**DEVELOPMENT ASSESSMENT REPORT**  
**Shire of Augusta Margaret River**  
**7 October 2021 to 13 October 2021**

**DEVELOPMENT APPLICATION ASSESSMENT**  
**Report to Manager Planning and Development Services**

**Proposed Single Dwelling**  
**97 (Lot 113) Baudin Drive, Gnarabup**

**P221546; PTY/7955**

**Figure 1: South Elevation – Point of Variation to Wall Height - Referenced in Red**

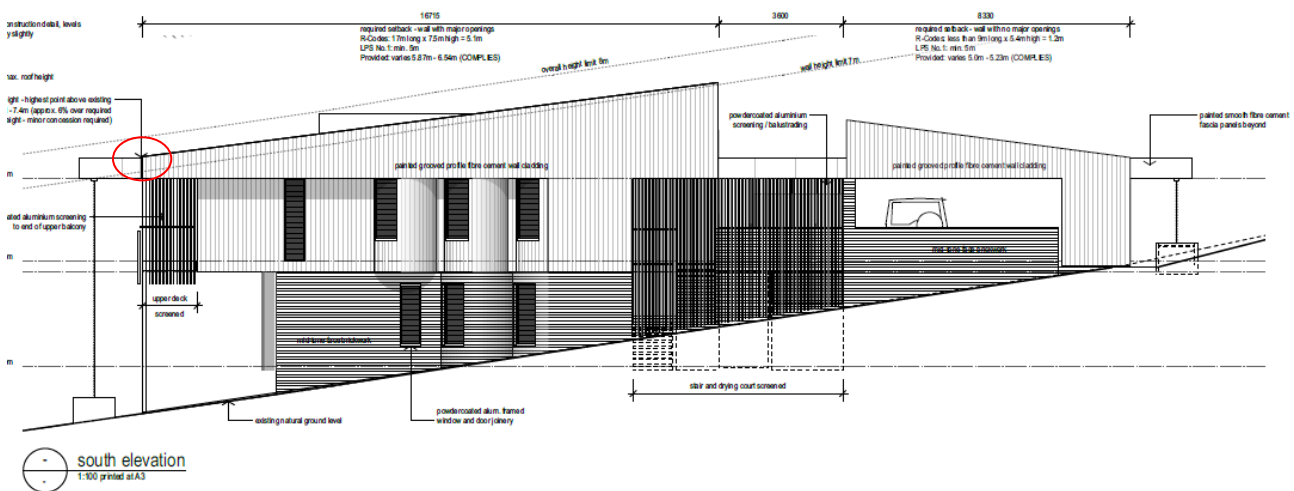
<b>Building Height</b>	
Scheme / Policy Requirement	Wall – 7m      Roof - 8m Does not comply (Wall Height)
State the proposed building height	Wall – Maximum of 7.4m in the south-west corner of the dwelling from natural ground level where the land slopes down Roof – 7.4m
<b>Officer Comment</b>	<p><b>Local Planning Scheme No. 1 Clause 5.13.2</b> The proposed 400mm wall height variation is assessed against the provisions of Clause 5.13.2 of LPS1 which provides for variations to the building height where site constraints prevent construction without exceeding the height limit, the nature of the building to be functional must be built to a higher level, or other extraordinary circumstances exist.</p> <p>In this case the site has a steep slope downwards from the front lot boundary (east) to the rear lot boundary (west). The building exceeds the 7m wall height guideline only where the slope of the site is greatest corresponding the south-western corner of the dwelling. The proposed dwelling design has a concealed roof and therefore the wall height corresponds to the roof height. The roof is a skillion design and responds to the slope of the land with the height variation corresponding to the lowest ground level for the dwelling site. In this regard the building design responds to the site constraints.</p> <p>The design also provides for a single storey development fronting Baudin Drive reducing perceived building bulk impacts to the street. The design of the dwelling avoids unnecessary extensive fill and responds to the natural levels of the site. The variation is considered reasonable in order to respond to the sites natural topography with the design ameliorating any impact of building bulk on surrounding properties. The wall height variation will not have any impact on the streetscape or amenity of the surrounding area. Furthermore, there will be no adverse impact in relation to access to sunlight to adjoining properties, major openings of habitable rooms, or active habitable spaces of neighbouring properties.</p>

5. The building wall height shall not exceed 7.4 metres from natural ground level in accordance with the provisions of Local Planning Scheme No.1.
6. A licenced surveyors report shall be submitted to the Shire within 30 days of completion of the building to confirm compliance with the maximum height limit.
